Docket Number:	16-AAER-02
Project Title:	Appliance Efficiency Rulemaking for Computers, Computer Monitors, and Signage Displays
TN #:	214153
Document Title:	NRDC comments on CEC's proposed computer and monitor standards
Description:	N/A
Filer:	System
Organization:	Natural Resources Defense Council (NRDC)/Pierre Delforge
Submitter Role:	Public
Submission Date:	10/24/2016 11:22:00 AM
Docketed Date:	10/24/2016

NRDC Comments on CEC Proposed Regulations for Computers and Computer Monitors

2016 Appliance Efficiency Rulemaking
Docket Number 16-AAER-2

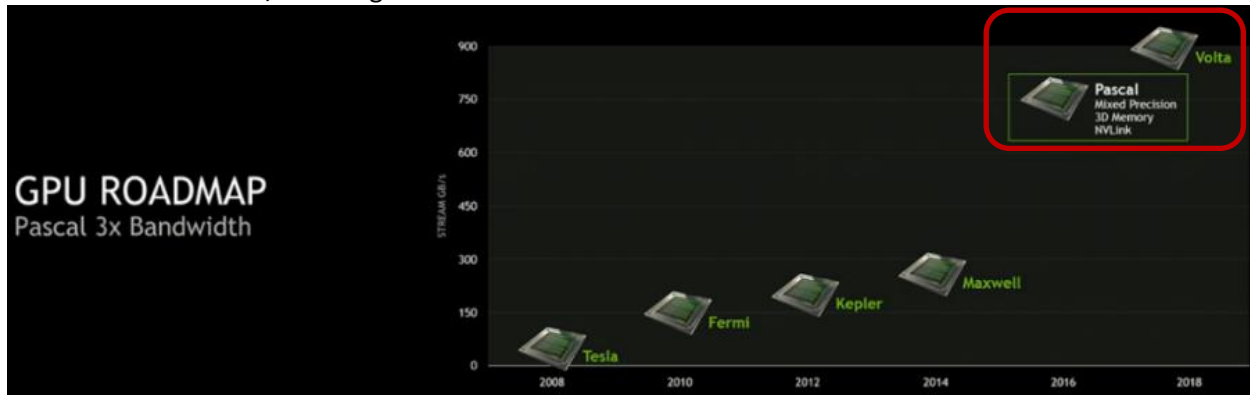
The problem is that these values will likely be common in the computer market by 2019 and 2021. AMD and NVIDIA’S product roadmaps show planned introductions of top-end GPUs that exceed both thresholds by 2017, two years before tier 1 and 4 years before tier 2. These new architectures are likely to be common across enthusiast platforms by 2019, and perhaps across most product lines by 2021.

AMD already released a GPU with 512 GB/s in 2015, and is planning to release GPUs with 1 TB/s in 2018.⁸

Figure 1: Idle Power Draw of AMD Radeon R9 Fury X¹²

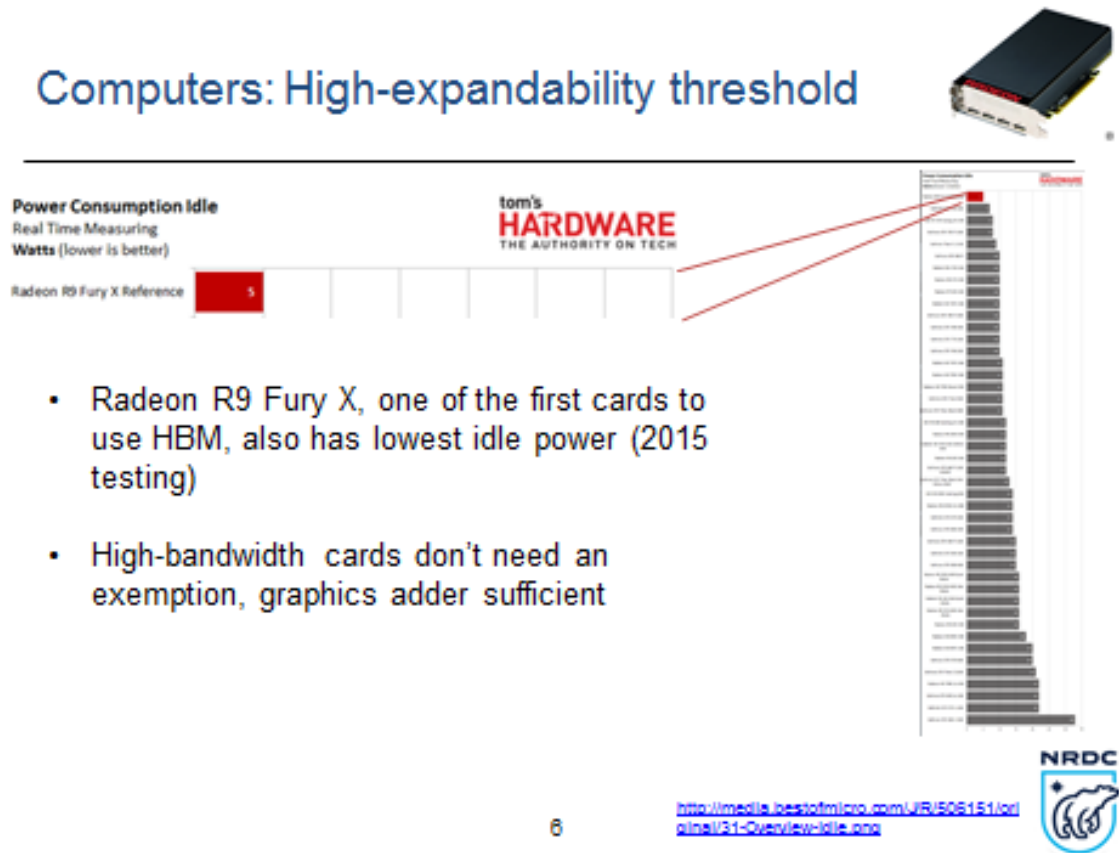
In addition, power data from the AMD R9 Fury X, the GPU that has the highest frame buffer bandwidth on the market currently, is also the most efficient of high-end GPUs currently on the market. **Therefore there is no evidence that discrete GPUs with high frame buffer bandwidth need an exemption**, on the contrary the only power data currently available shows that they can achieve standards levels with the discrete graphics adder.

The inclusion of integrated graphics in the exemption criteria makes the risk of loophole even higher. By including integrated graphics in the scope of the exemption, CEC risks making this loophole larger, as it could then apply to all computers on the market, vs. only those with discrete graphics. The lack of evidence on the need for an exemption discussed above applies to integrated graphics too. CEC’s proposal already provides an adder for high-bandwidth memory, and these forms of memory tend to be more efficient than conventional types of memory, therefore the HBM adder is sufficient. **NRDC strongly recommends eliminating this exemption for both discrete and integrated graphics.**

Given the uncertainty in projecting this performance characteristic several years out, and the lack of evidence that these cards require an exemption and cannot achieve the standards with the normal graphics adder (market data suggests they can per the AMD Fury X GPU), **NRDC recommends the following exemption thresholds:**

Tier 1 (Jan.1, 2019)	1 TB/s, for GDDRx memory only
Tier 2 (Jan 1, 2021)	No exemption
